Alder Lake-S OEM & ODM CRD Survey Report (Desktop Segment)

ACER, AS ROCK, ASUS, DELL, LENOVO, MSI, LITEON, FOXCONN, LCFC, ECS
2020 - WW45 Rev 0

3.2.2 Solder Paste Volume and Stencil Optimization

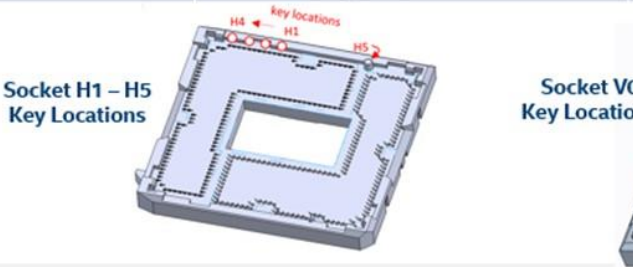
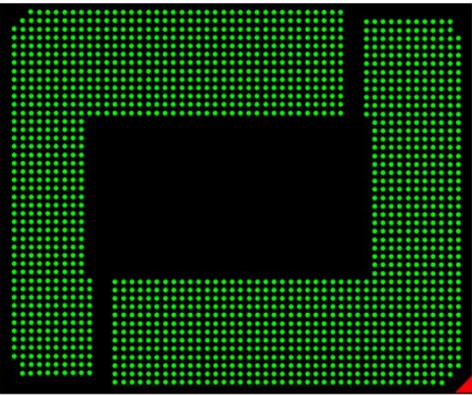
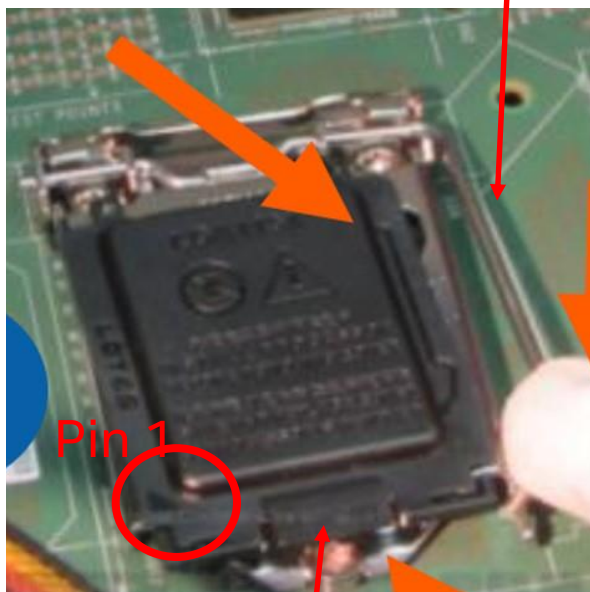
LOTES solder ball size is smaller than Deren & FIT, customer's concerns with SJQ with the same paste volume recommended in MAS across all socket supplier.

- This aperture size shown here may not be optimized for all socket suppliers.
- Intel is currently investigating a larger aperture size stencil to mitigate any HnP or Opens risk, in the Air Reflow Environment

Which Pin 1
label is
correct ?

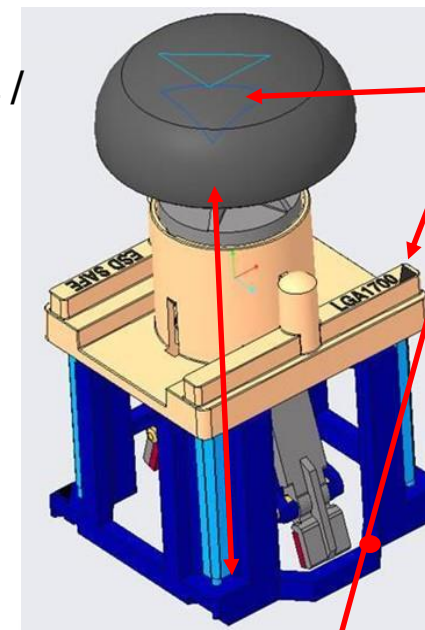
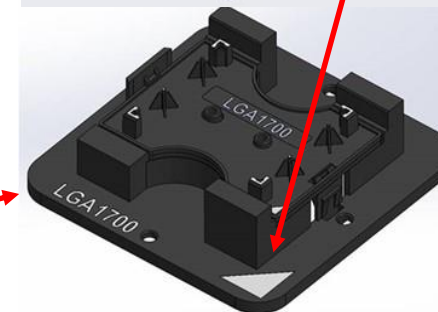
This site facing operator
(it will be inconvenient for same operator to process
skt-H and skt-V, and possibly error in execution, due
to the need to rotate the processor 180° orientation)

Pin 1, diagonally
opposite compare to
skt-H & also PnP tool /
stage

The Pin 1 mark
on tools are
inconsistent to
Pin 1 indicator
on PCB

- 1) Operator needs to rotate processor 180° from PnP tool/stage in order to align to PCB Pin 1.
- 2) Any possibility to make changes for socket-V the ILM to allow customer process transparency and mitigate execution error for manual process ?eg. 180° marking orientation change on ILM cover marking

Manual Assembly risk

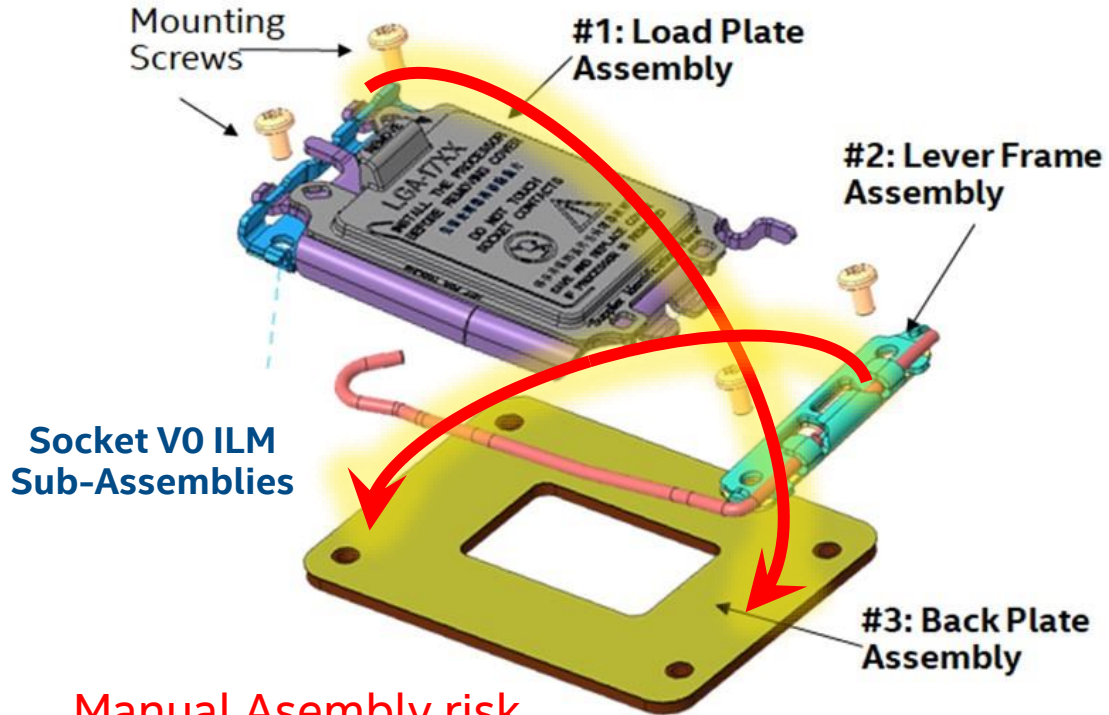
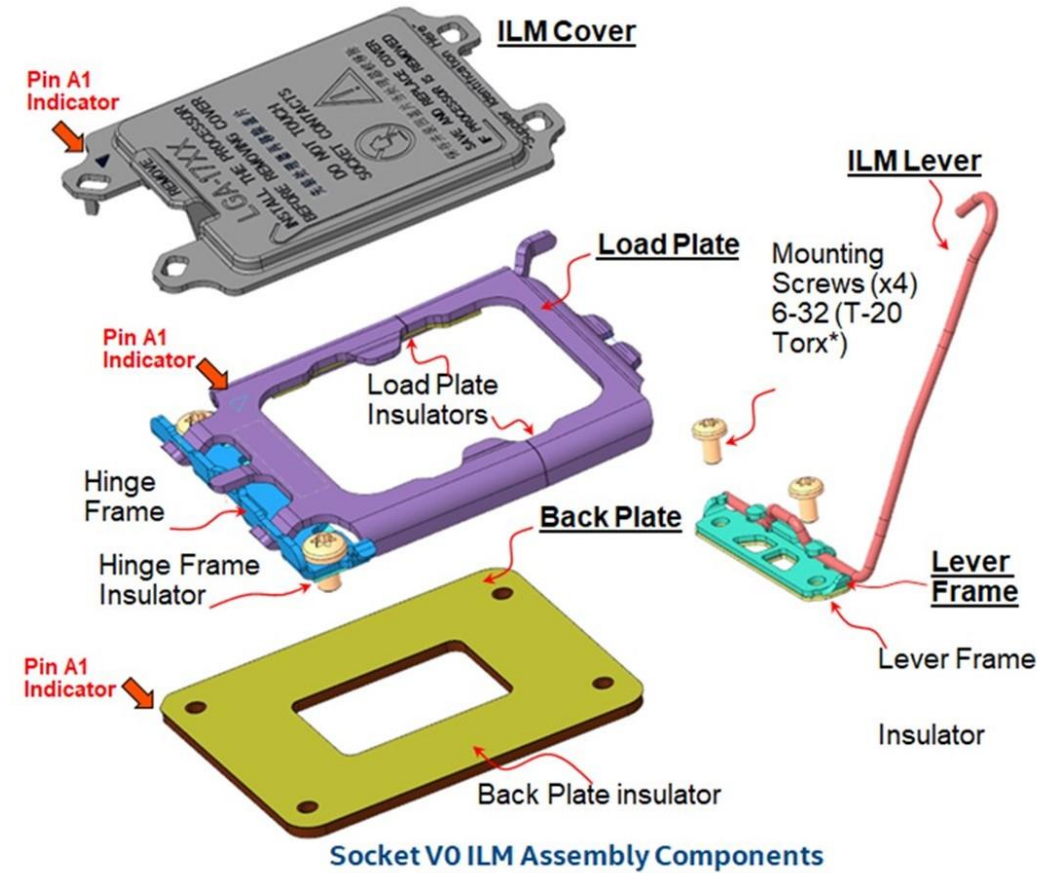
- 1) PCB Top Side> Potential/risk for operator swapped lever frame and load plate locations during assembly.
- 2) Backplate> Potentially 180° orientation assembled.

Piece Parts Interchangability

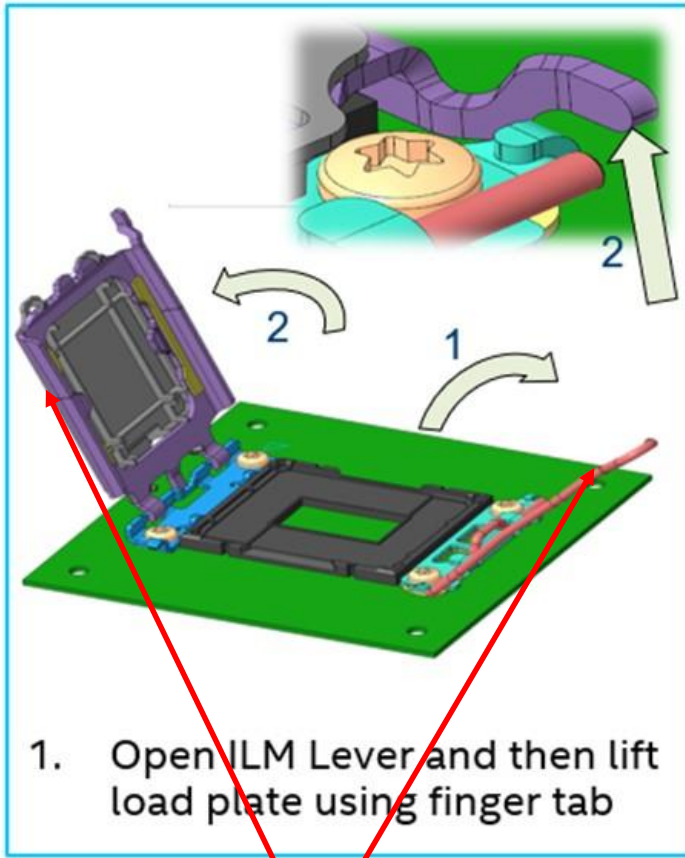
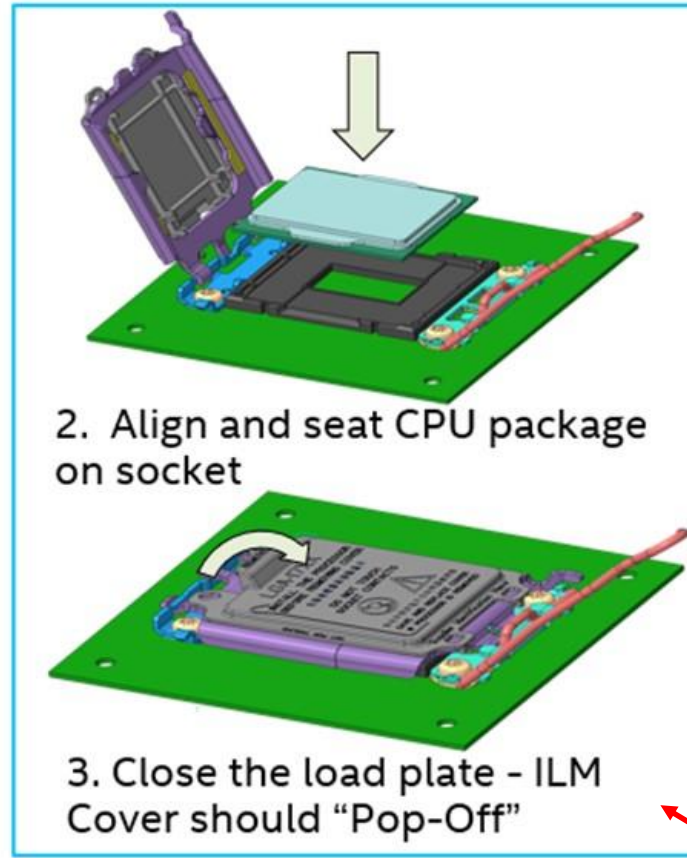
- 1) Need to ensure all 4 mounting screws are same part number# .
- 2) Allow mixed vendor for piece parts (including different socket vendors to ILM vendors).

Automation Assessment/concerns:

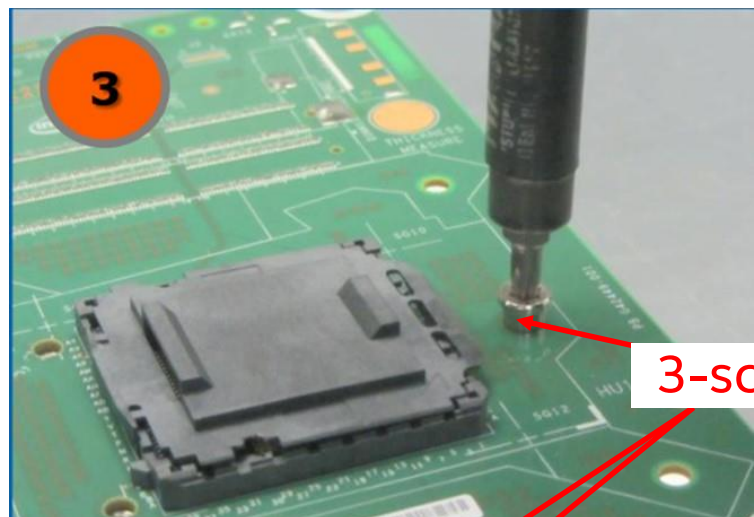
- 1) Will the top plate & lever arm will stay permanently (height & angle) when moving at conveyor belt to next process/operator to install processor ?
- 2) What is the height / angle of the top-plate and lever arm ?
(Machine PnP assessment)

Where is the locking position for load plate to push the ILM cover to pop-up ? Should the cover pop-up happen after lever is latch ?

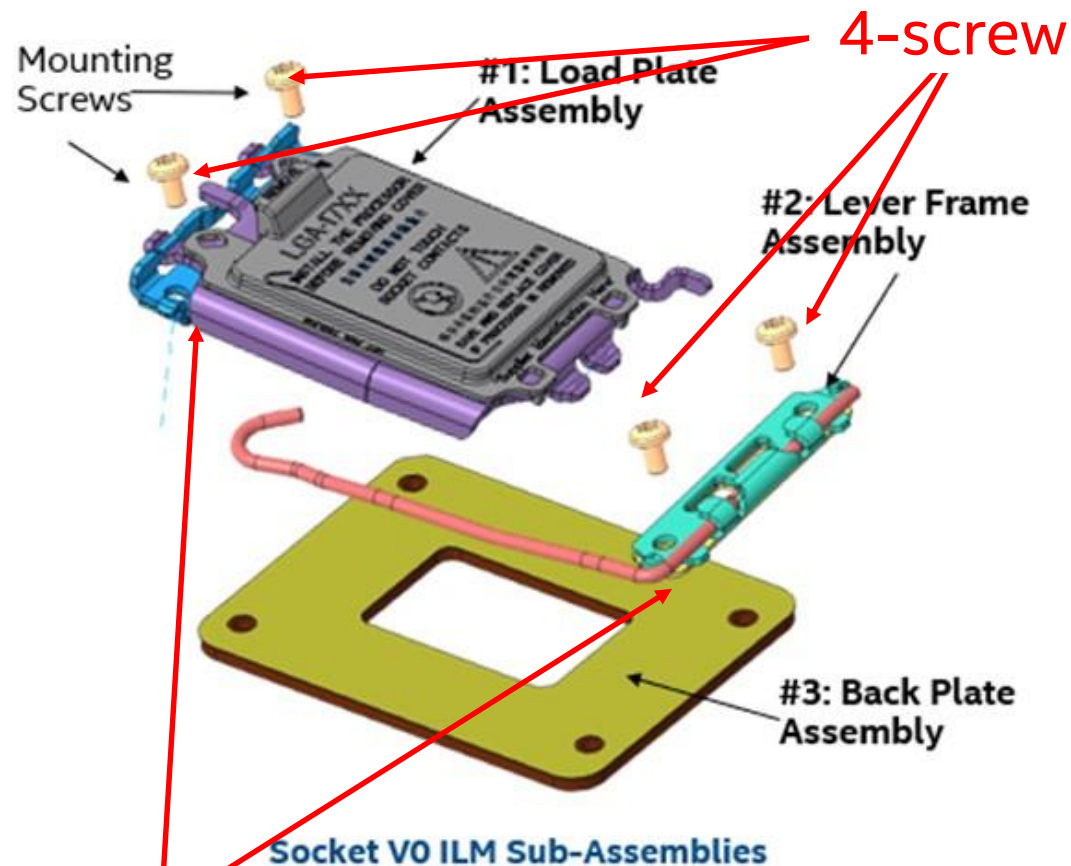
Customer needs to mix vendors for backplate, load plate, lever frame, screws & etc, is this allowable ?

6.7.6 Contact Failure Type 3: Y-Axis Shift

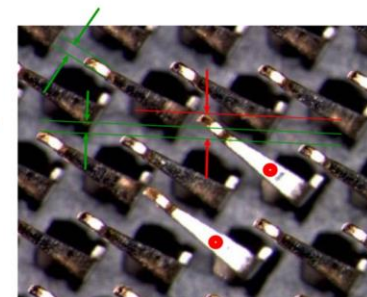
Tighter pitch but more relax criteria ?

- original >1 width vs current >1.5 width

Is the pin contact always contacted at the center of the LGA pad or near pad edge ? with the process variation and X-Y shift, will the pin be touching LGA Au pad or outside the Au pad (Solder resist area) or adjacent Au pad ? -- Need Intel design to assess
